# PRIMARY PLAT ART HARTIG SUBDIVISION

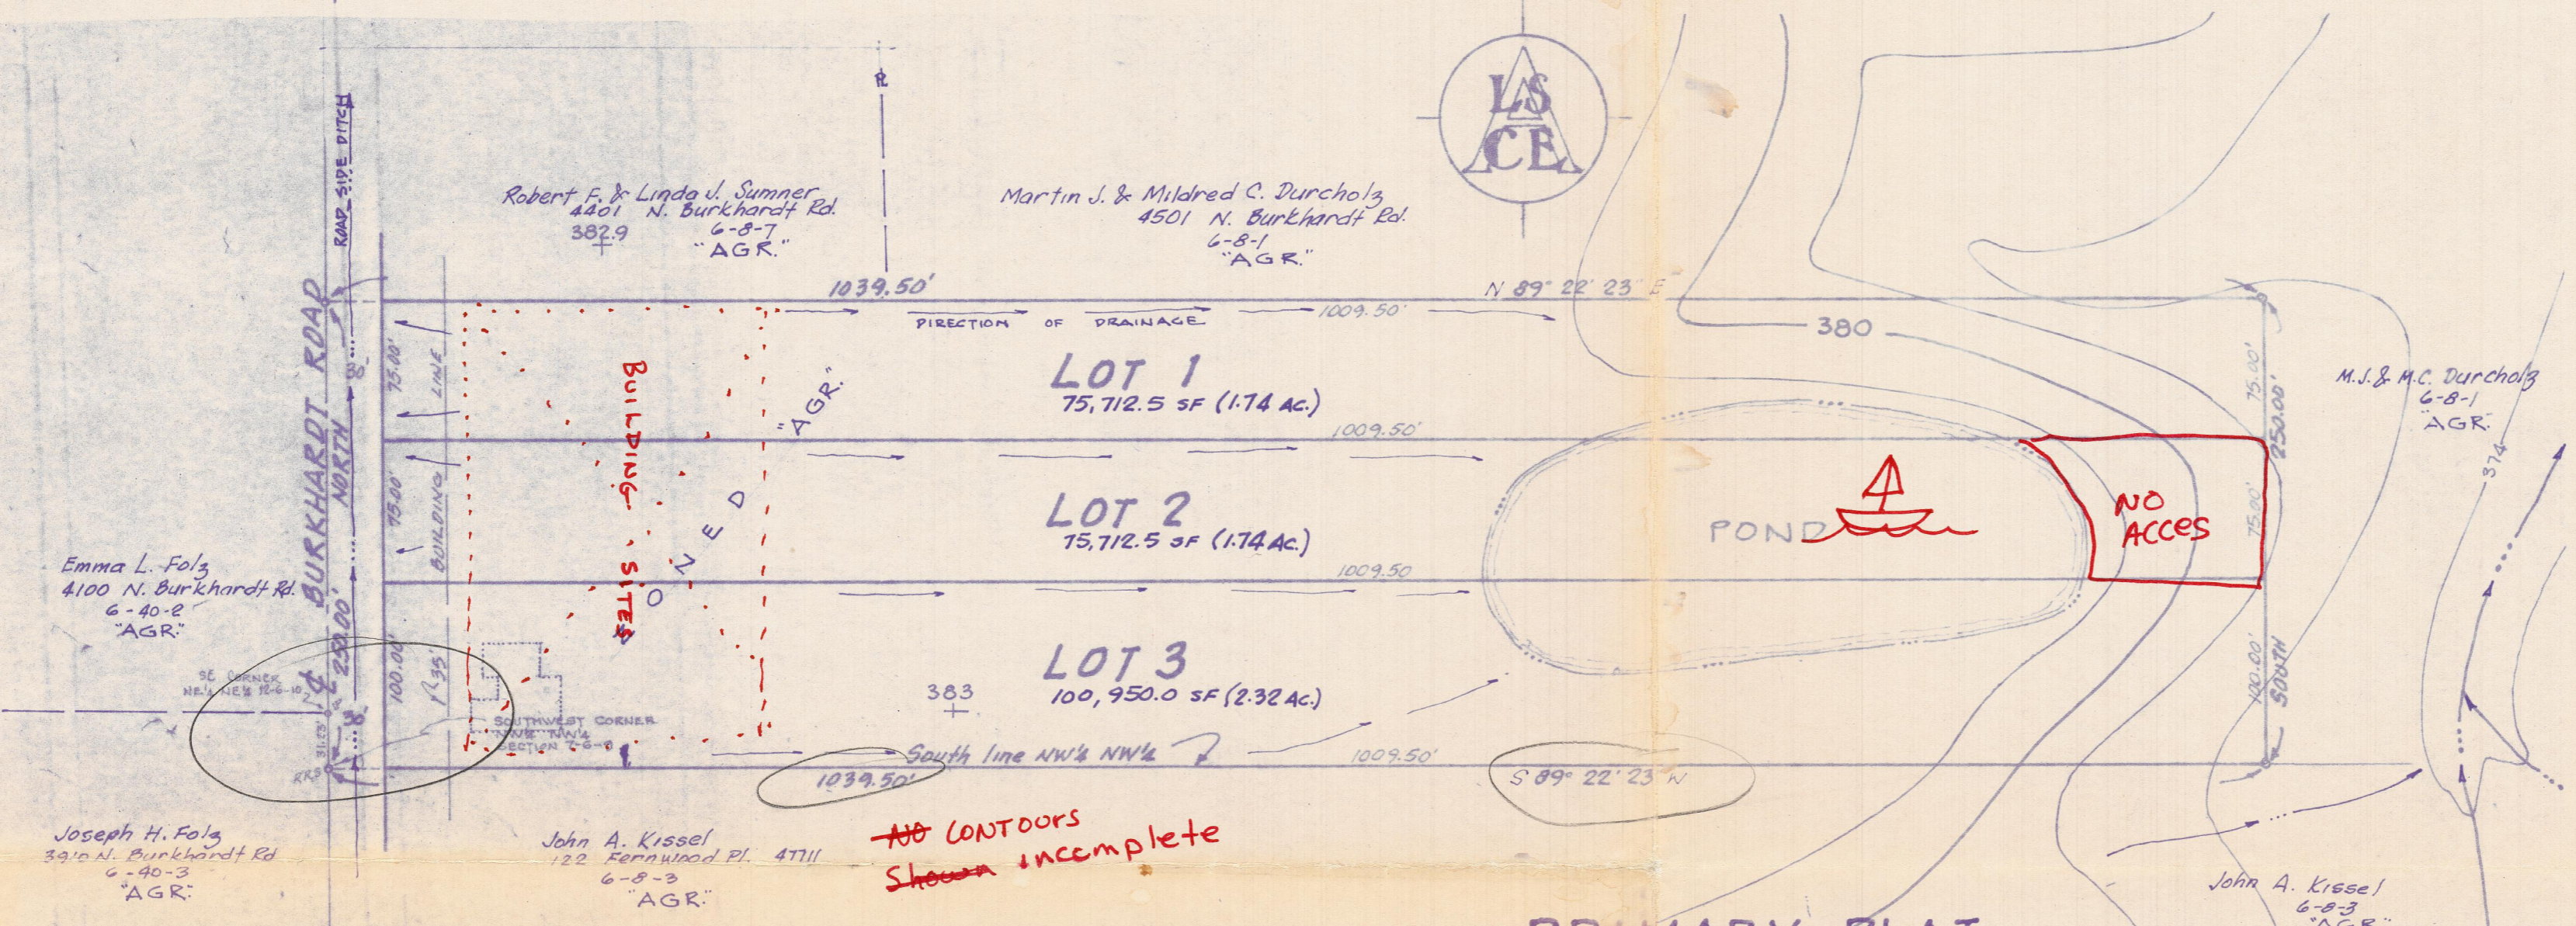
*NO CONTOURS  
SHOWN INCOMPLETE*

*LOTS EXCEED 3 TO 1 RATIO  
RETENTION calc. due to E. Side drainage  
May be subject to flash flooding also re May 2, 1983*
